March 2025 | Danfoss Climate Solutions for cooling

# Cool Update

## Notification of Change in Compressor Label Format for All Reciprocating Compressors MT, MTZ, NTZ, VTZ

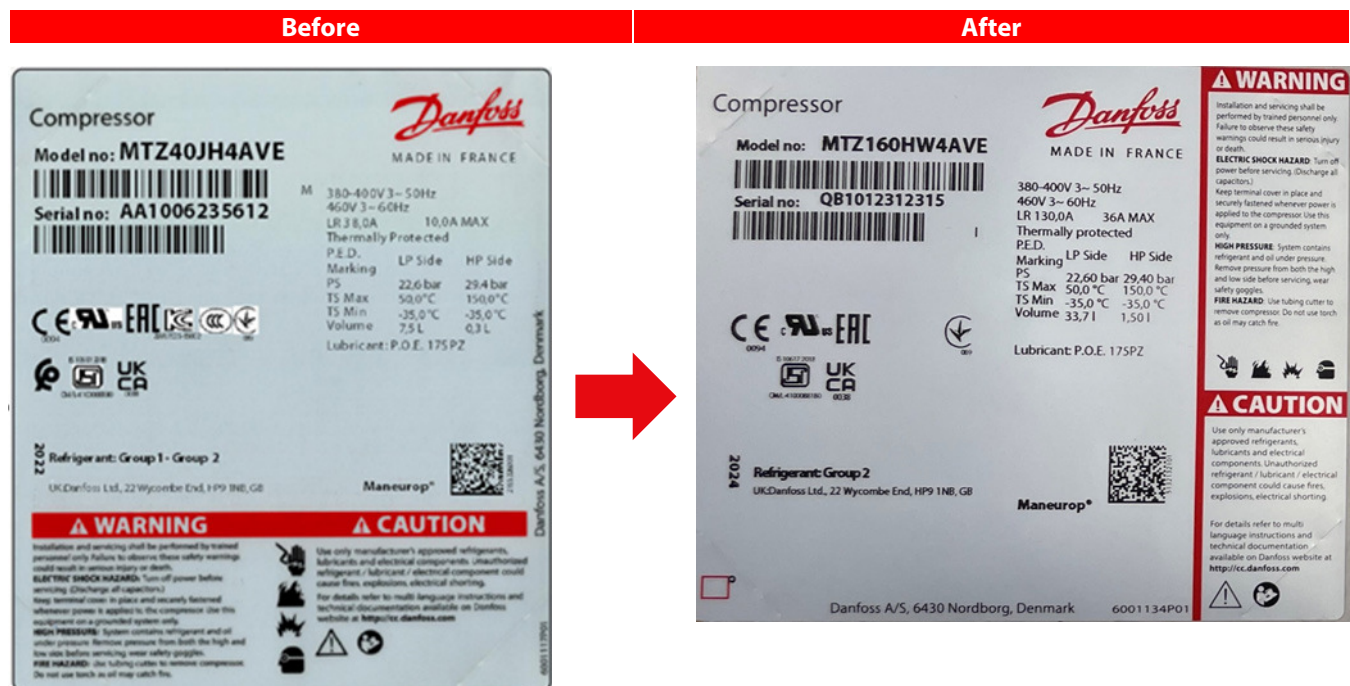
This is to inform you about an upcoming change in the format of our compressor labels. The shape of the label will transition to a horizontal version, commonly referred to as landscape.

All data on the label will remain unchanged; only the layout will be adjusted to better fit the compressor housing.

The images below illustrate the label before and after the change.

## Optyma™ Slim Pack DS034 Piping Change

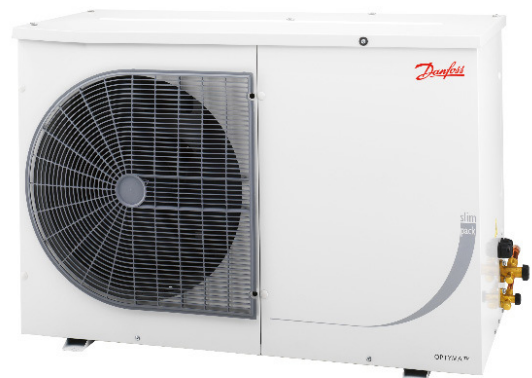
As part of Danfoss' continuous quality monitoring, due to infrequent and extremely rare abnormal vibration discovered in the field under very specific working conditions, we are pleased to announce that we have changed the discharge tube piping design for four models to prevent possible leakage and ensure reliable operation for years to come under all intended working conditions.

Under specific working conditions Optyma Slim Pack models equipped with the Danfoss DS34TB compressor have exhibited high vibration levels. In very few field cases, abnormal noise has been detected after several months of operation, which potentially might result in cracks on the compressor discharge port and subsequent system leaks.

## Affected products

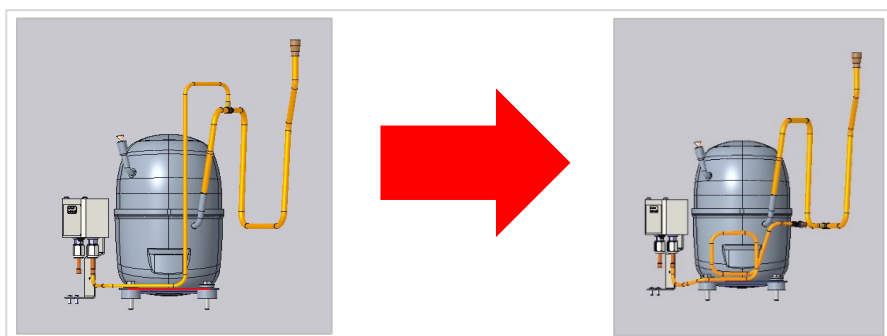
The DS34TB compressor exhibits higher vibration than the initial levels documented during the engineering of this model. This resulted in uncomplete vibration simulation and consequent design of the discharge piping line.

The new design will ensure the flexibility and reliability of the brazed parts.

- W05 version: All products on stock and produced after week 02 2025 have been modified
- W09 version: All products produced after week 10 2025 (to be updated)

For products on field and abnormal vibrations experienced, produced before this date we have created a kit to change the piping – there is no need for pro-active modification if no abnormal vibration experienced.

- Kit article code: 118U5588
